ARCHITECTURAL SUPPLEMENTAL INSTRUCTION:
ALL TERAZZO INSERT DIMENSIONS (TOTAL WD & HGT) ARE 1/4" MODULAR TO FIT WITHOUT
IRREGULAR OR ADDITIONAL TILE CUT INTO 1/4"X28" FLOOR TILE PATTERN.
TERAZZO AND TILE CONTRACTOR ARE REQUIRED TO COORDINATE AND
CONFIRM FINAL SIZE AND PLACEMENT OF TERAZZO ART INSERTS.

**ST PETE CLEARWATER AIRPORT
INTERIOR TILE PROJECT**
(IN ADDITION TO CORRIDOR TILE PROJECT)

Drawing Name:
**FLOOR PLAN
TERAZZO DETAIL**

Drawing Number:
I.1.10

08 TERAZZO DETAIL
1" = 1'-0"

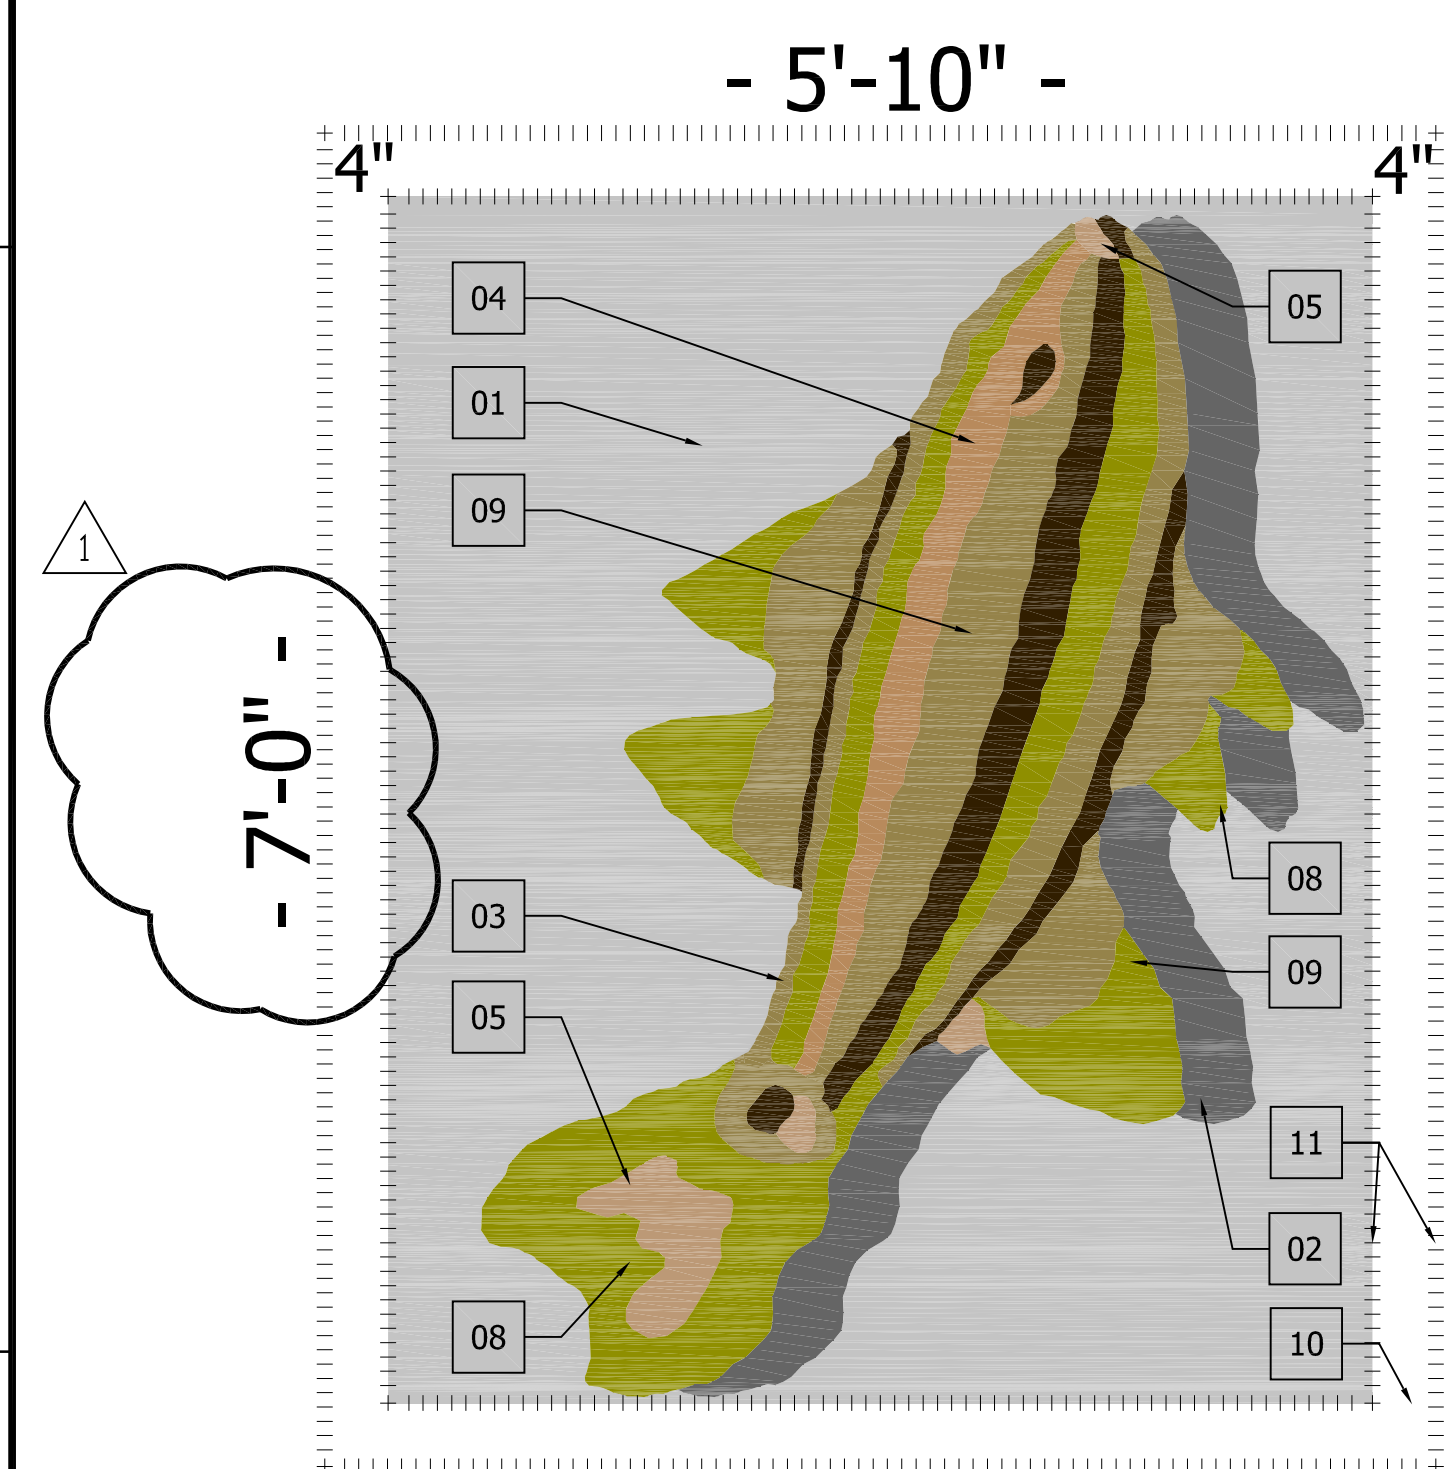
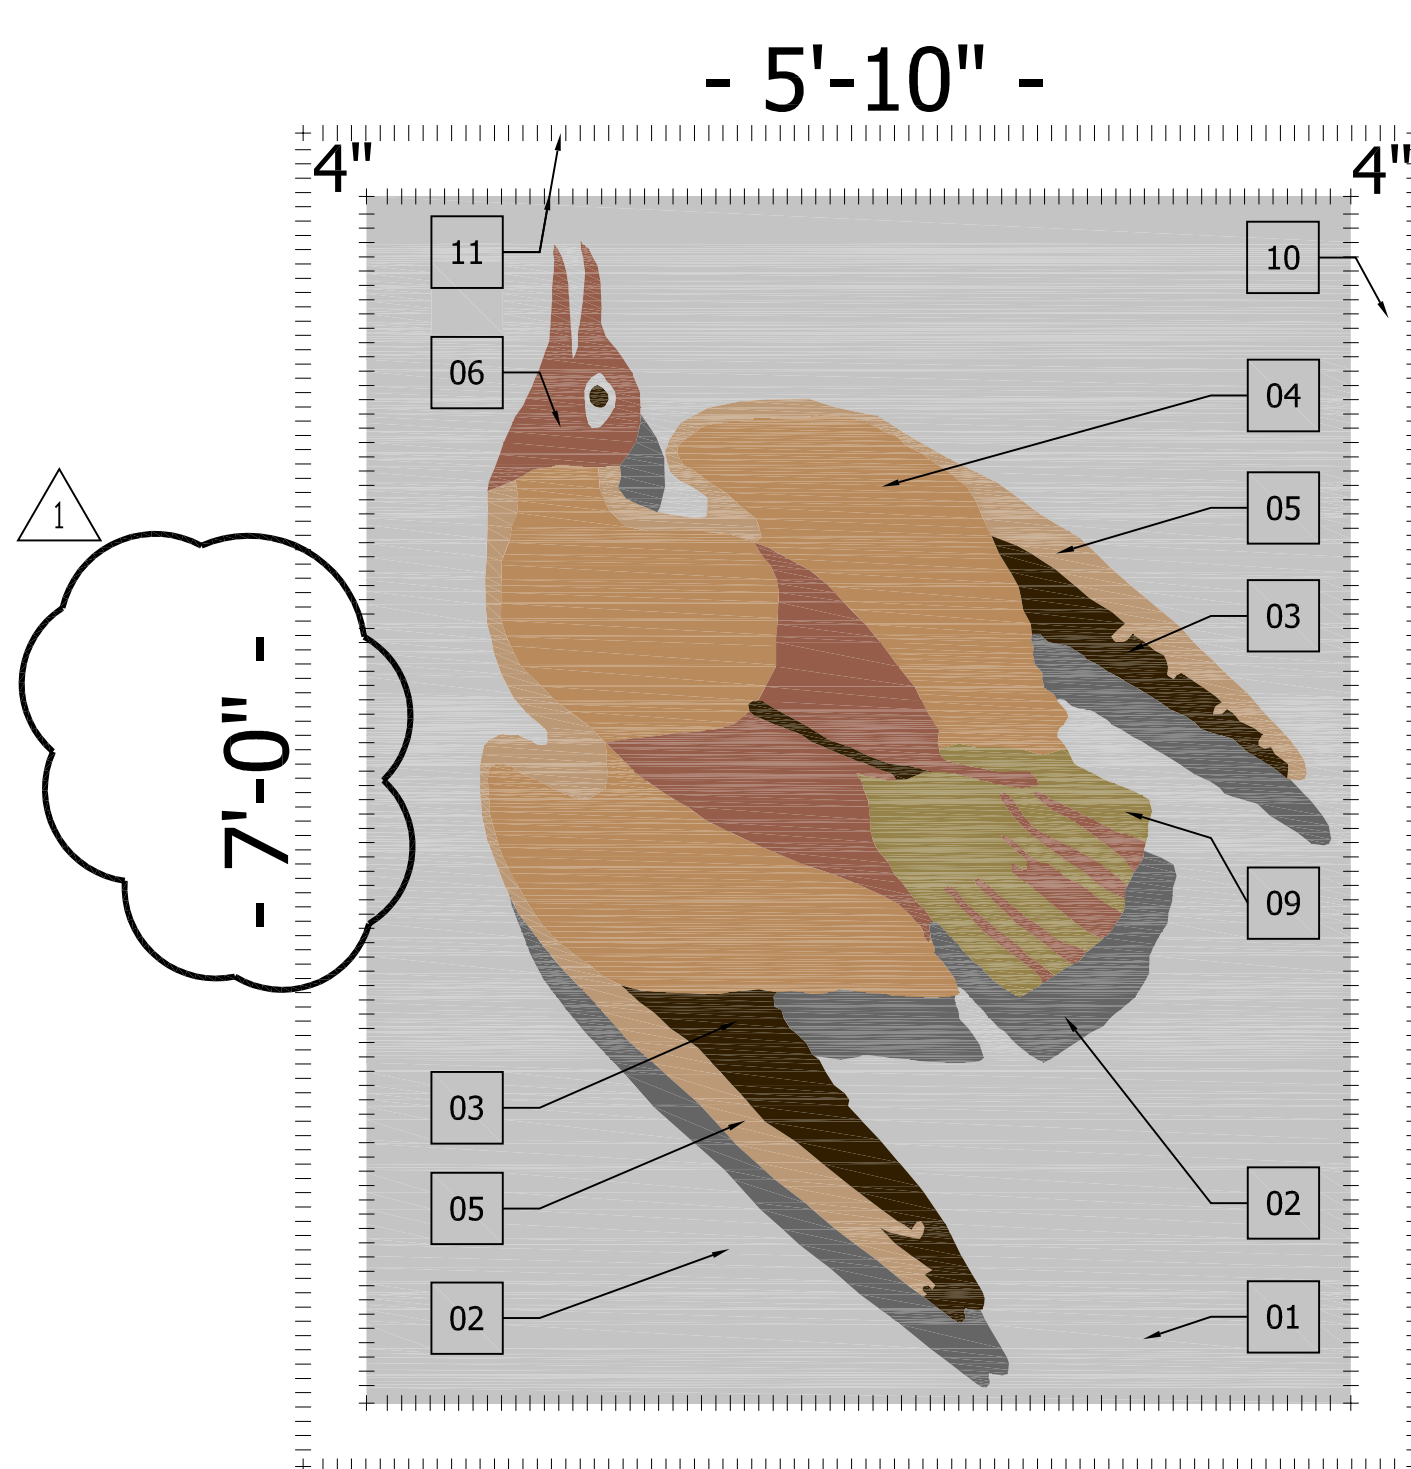
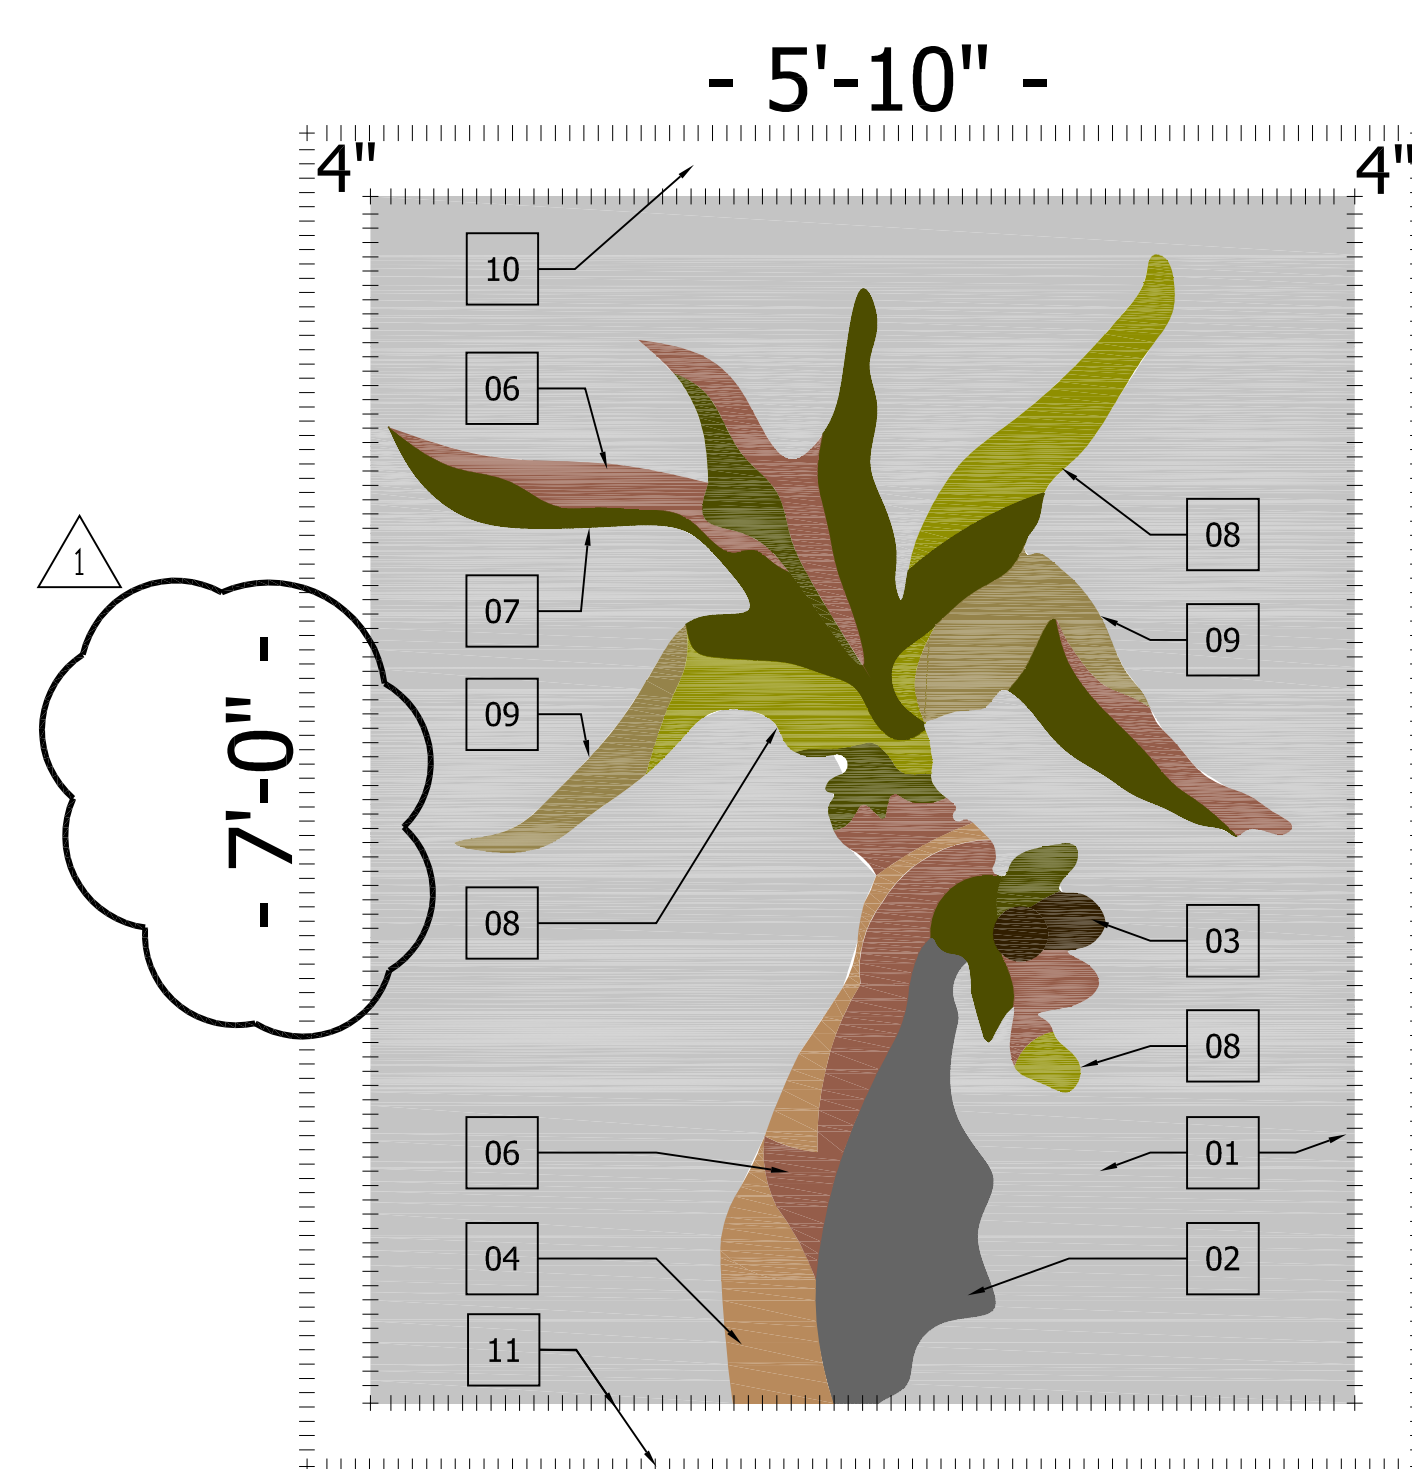
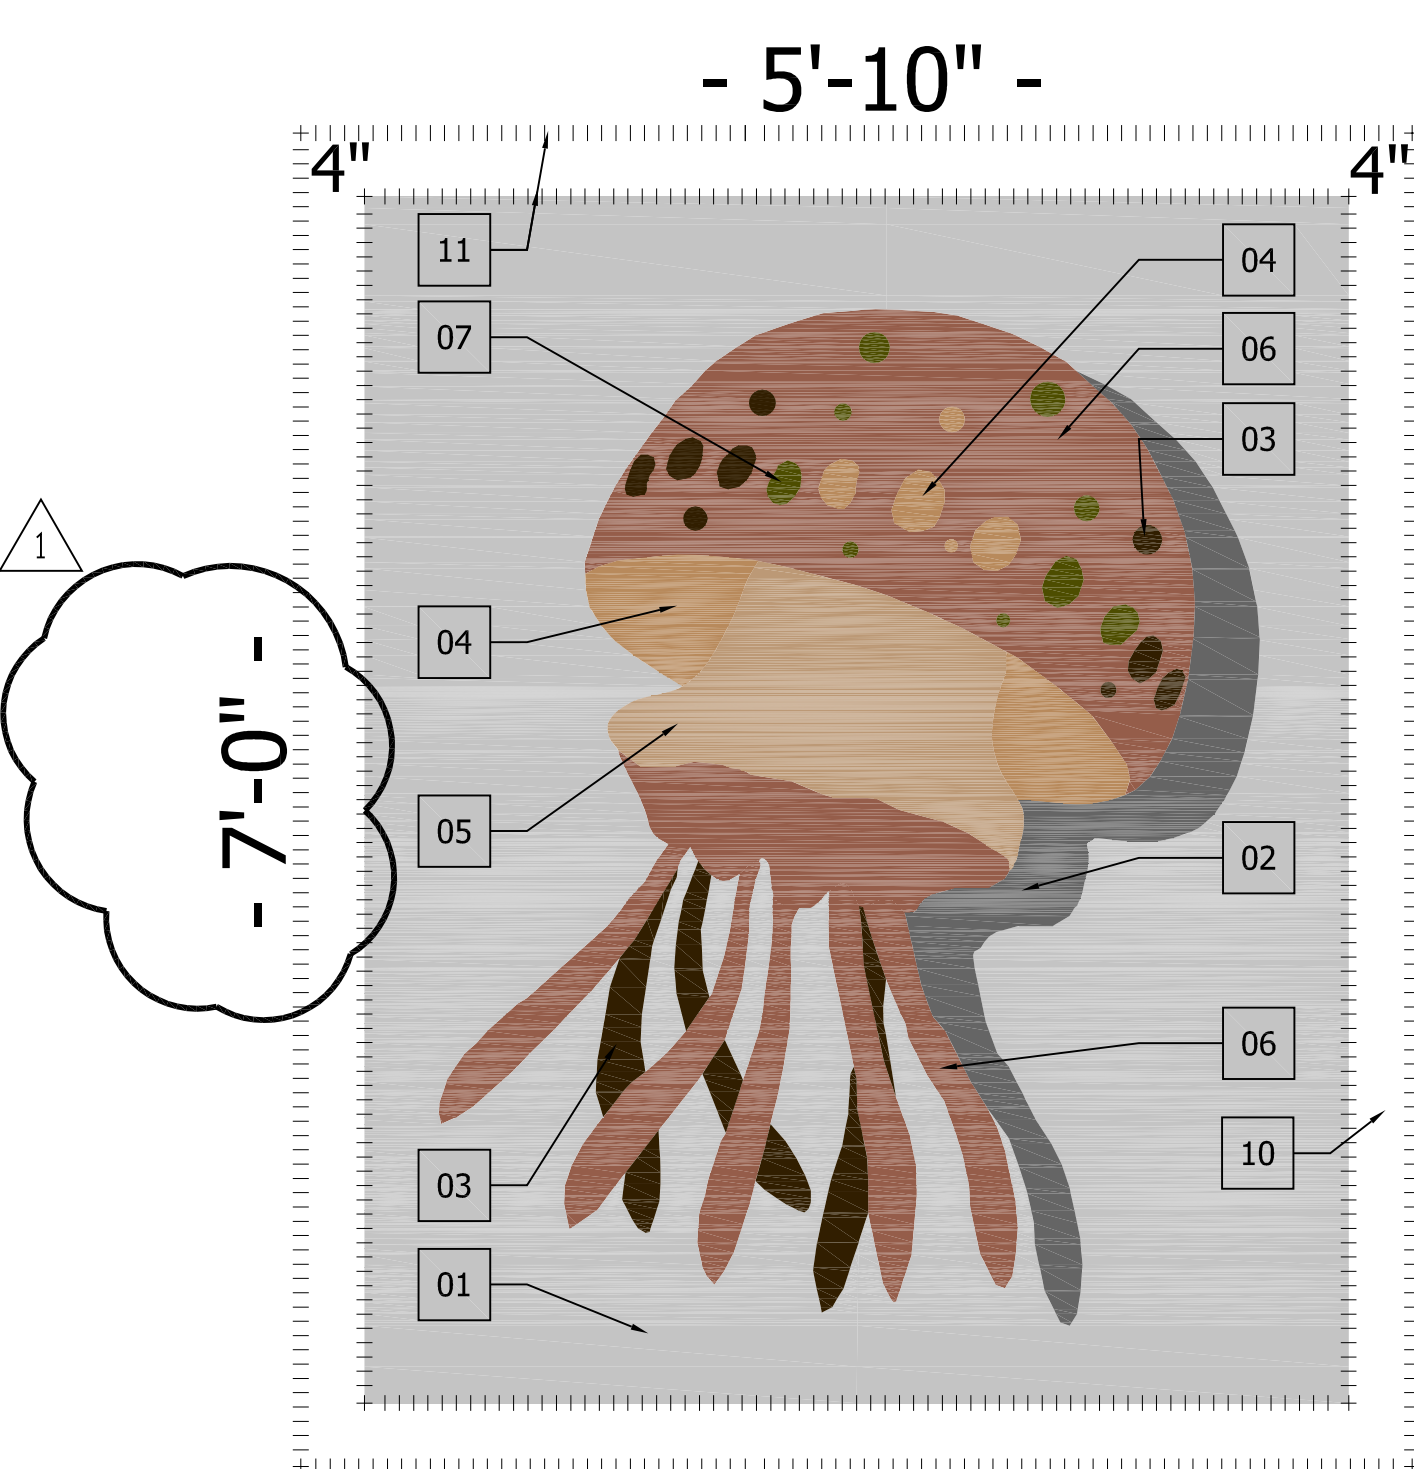
| No. | Description | Date | By |
|-----|------------------------------|----------|----|
| 1 | ASH: CORRECTION OF TOTAL HGT | 07.06.09 | SB |
